Appendix A1

Public Domain
Updates

Markup Diagram

Changes to Public Domain Diagram

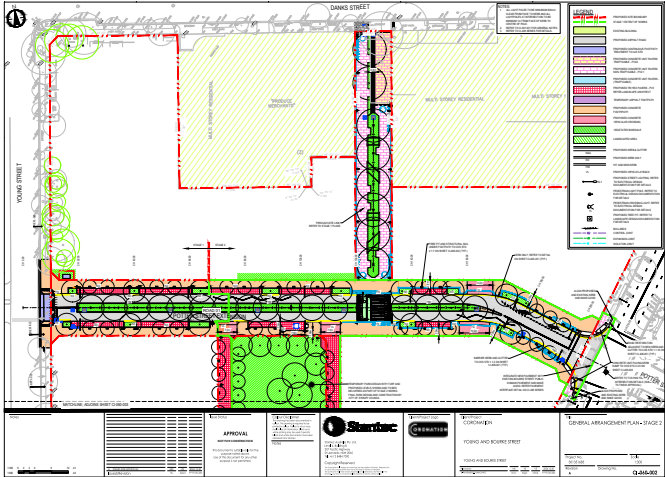
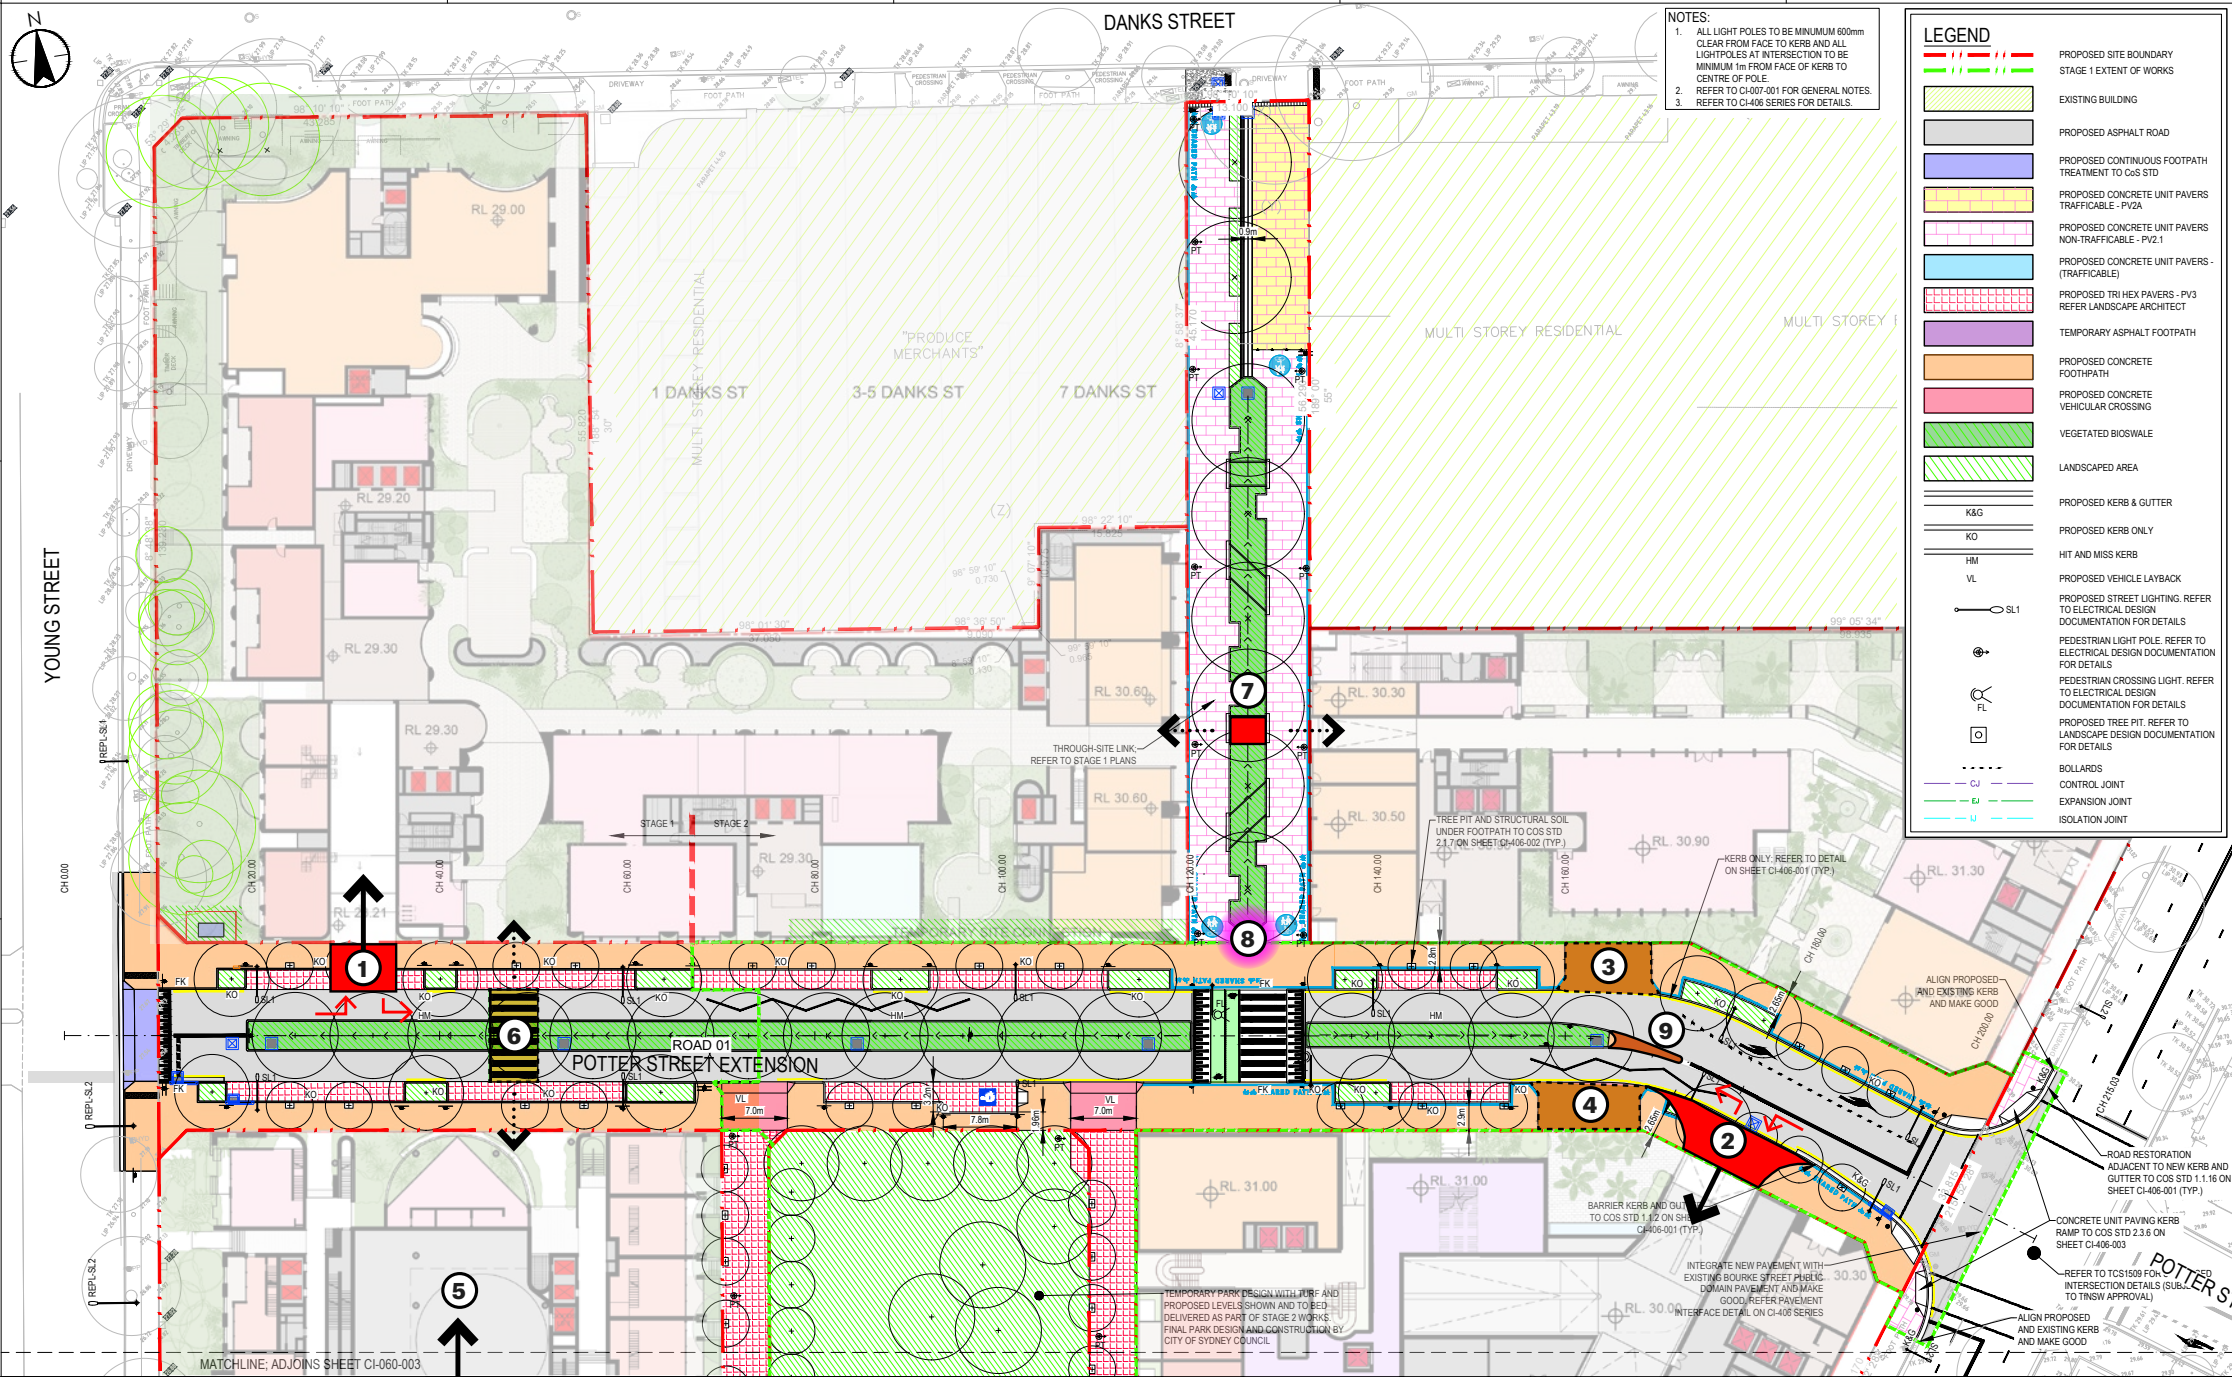
The adjacent diagram represents and overlay of the approved public domain and proposed ground plane, identifying key areas of the public domain that will require modification. The proposed amendments under design development have a separate lodgment and approval pathway with the City of Sydney

- 1. **New Crossover**
Cars and SRV's
Left in, Left Out
- 2. **New Crossover**
All vehicles
Left in, Left Out
- 3. **Removed Crossover**
Additional Street trees
- 4. **Removed Crossover**
Additional Street trees
- 5. **Parcel 4**
Vehicle servicing from Southern laneway
- 6. **Additional Crossing**
Providing safe connection to shared amenities
- 7. **Landscape Break**
Facilitating pedestrian movement across sites
- 8. **Public Art Co-Ordination**
Location and type TBC
- 9. **Median**
Concrete median reduced to landscape zone, painted linework to curved end to facilitate left out for large vehicles
